Attachment 4

Proposed Tech Spec Change Retyped

Figure B 3.6.6-1
 Containment Spray and NaOH Systems

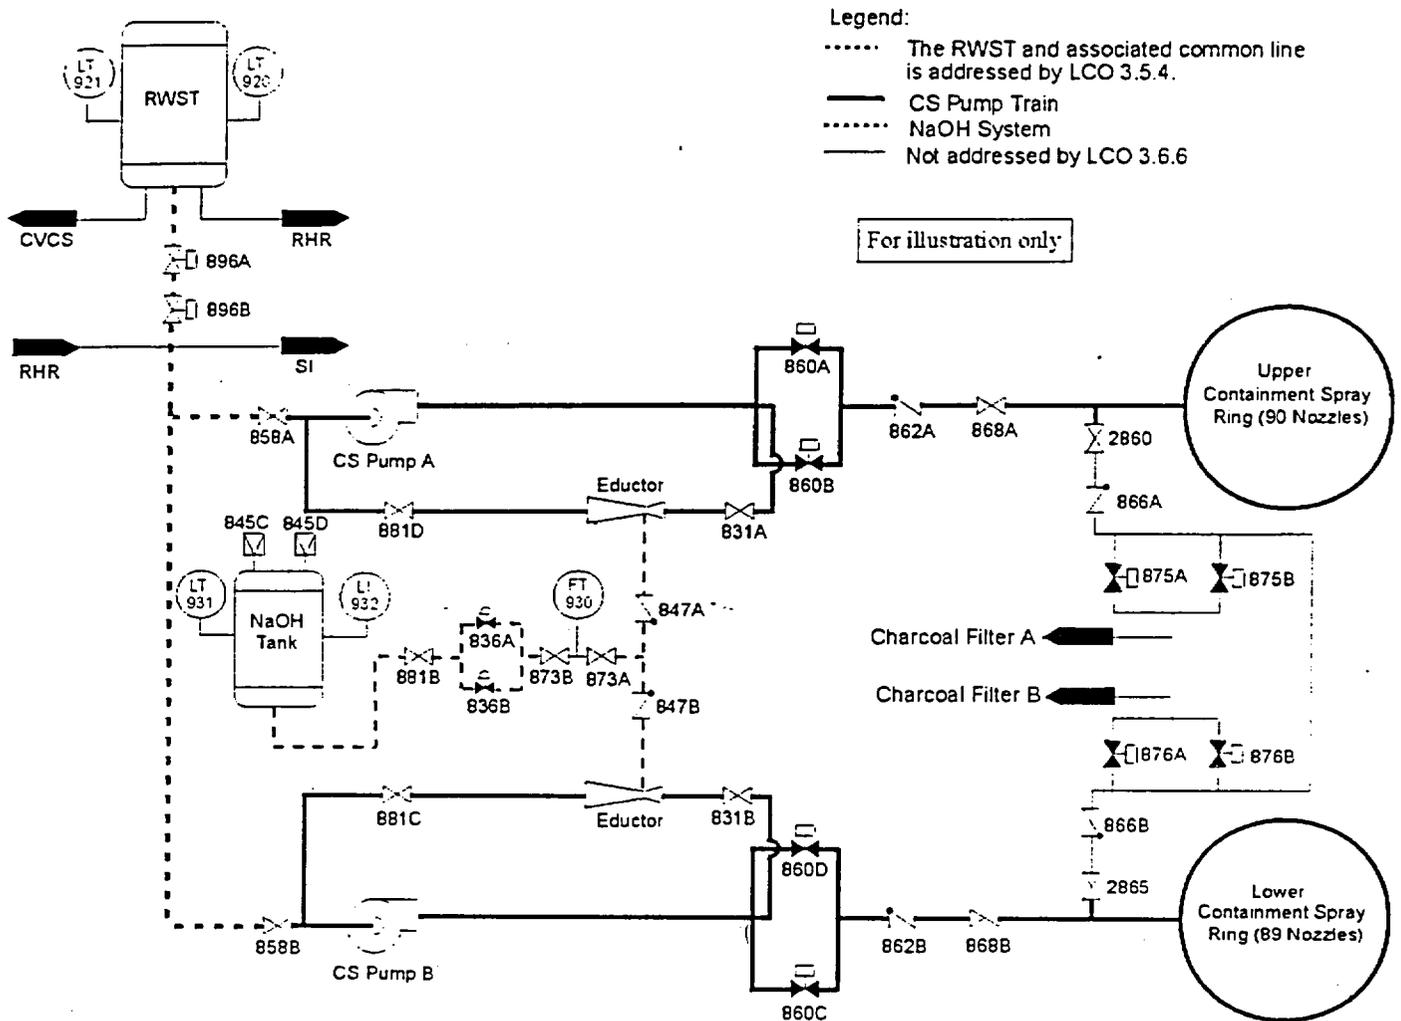
The CS System consists of two redundant, 100% capacity trains. Each train includes a pump, spray headers, spray eductors, nozzles, valves, and piping (see Figure B 3.6.6-1). Each train is powered from a separate ESF bus. The refueling water storage tank (RWST) supplies borated water to the CS System during the injection phase of operation through a common supply header shared by the safety injection (SI) system. In the recirculation mode of operation, CS pump suction can be transferred from the RWST to Containment Sump B via the residual heat removal (RHR) system.

The NaOH mixture is injected into the CS flowpath via a liquid eductor during the injection phase of an accident. The eductors ensure that the pH of the spray mixture is a caustic solution. ~~The resulting alkaline pH of the spray enhances the ability of the spray to scavenge fission products from the containment atmosphere.~~ The NaOH added in the spray also ensures an alkaline pH for the solution recirculated in the containment sump. The alkaline pH of the containment sump water minimizes the evolution of iodine and minimizes the occurrence of chloride and caustic stress corrosion on mechanical systems and components exposed to the fluid (Ref. 2).

Figure B 3.6.6-2
 CRFC and Containment Post-Accident Charcoal Systems

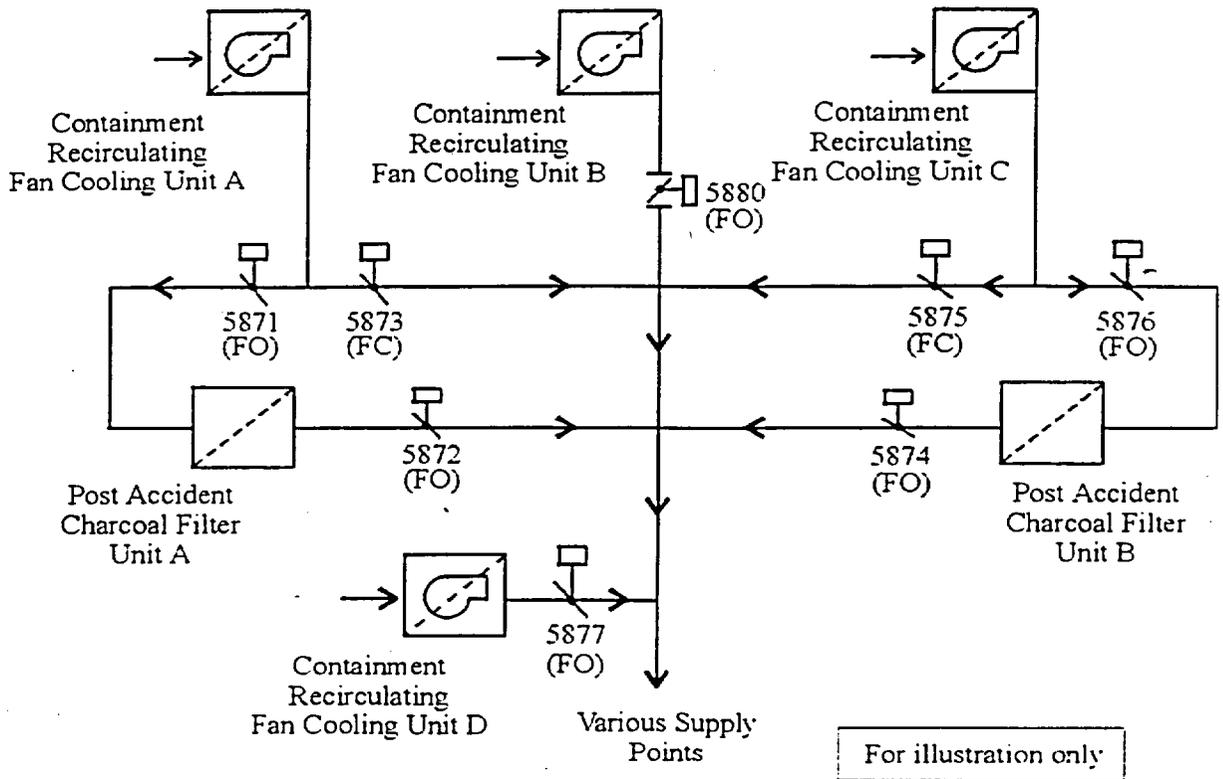
The Containment Post-Accident Charcoal System consists of two redundant, 100% capacity trains. Each train includes an airtight plenum containing two banks of charcoal filter cells for removal of radioiodines (see Figure 3.6.6-2). Air flow enters the plenum through two holes in the bottom (one at each end), passes through the charcoal filter banks to the center, and is exhausted from the plenum through a hole in the top. Two normally closed air operated dampers isolate each post-accident charcoal filter train from CRFC units A and C (dampers 5871 and 5872 for Train A and 5874 and 5876 for Train B). A SI signal opens these dampers and closes two bypass dampers from the CRFC units (dampers 5873 for CRFC unit A and 5875 for CRFC unit C) to force flow through the post-accident charcoal filters.

~~Required Action F.1 is modified by a Note which states that this required action is only applicable if CRFC unit A or C is inoperable. The loss of CRFC unit A or C results in the associated post-accident charcoal filter train being inoperable since the post-accident charcoal filter trains do not have their own fan assembly.~~

Figure B 3.7.9-1
CREATS

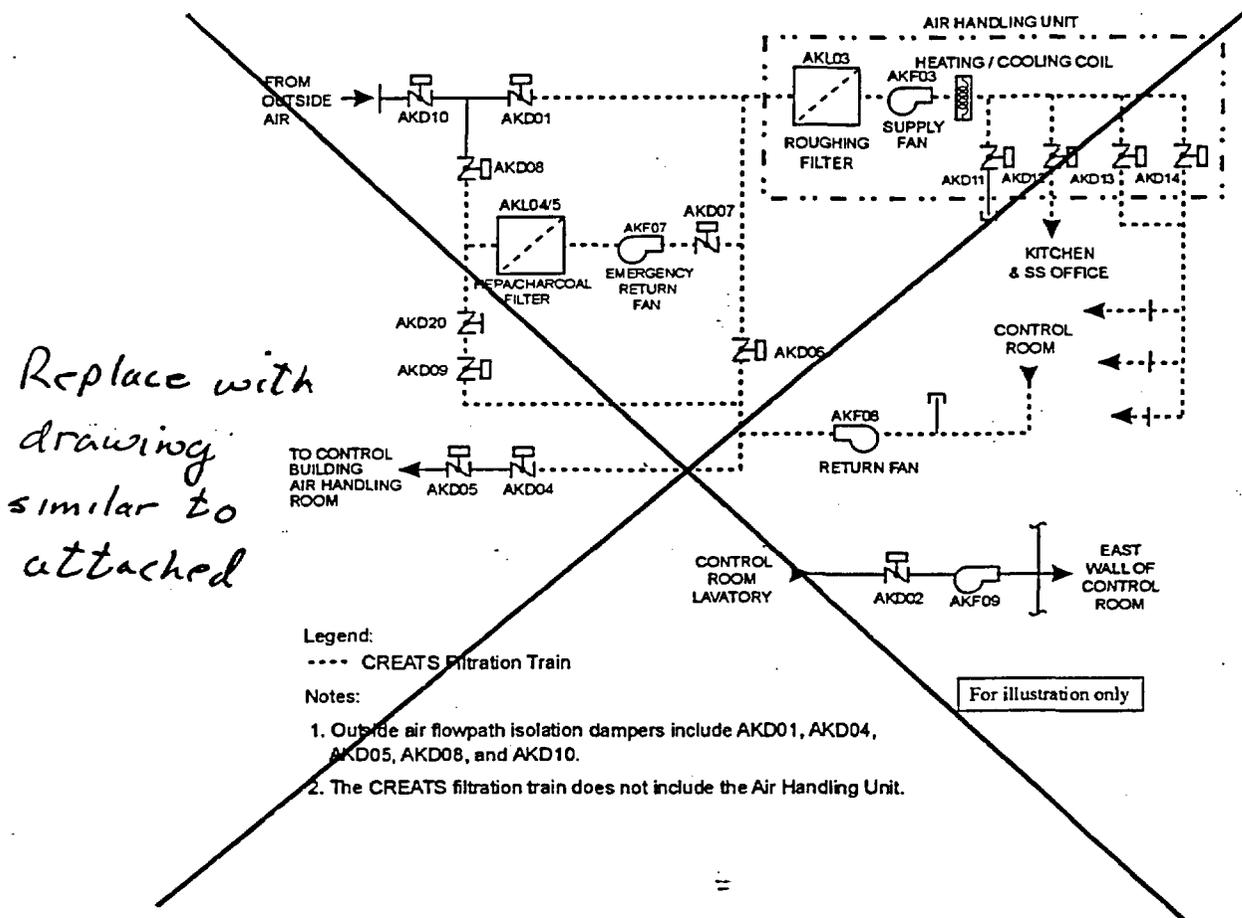
The CREATS is considered OPERABLE when the individual components necessary to permit CREATS Mode F operation are OPERABLE (see Figure B 3.7.9-1). The CREATS filtration train is OPERABLE when the associated:

*Replace with
attached*
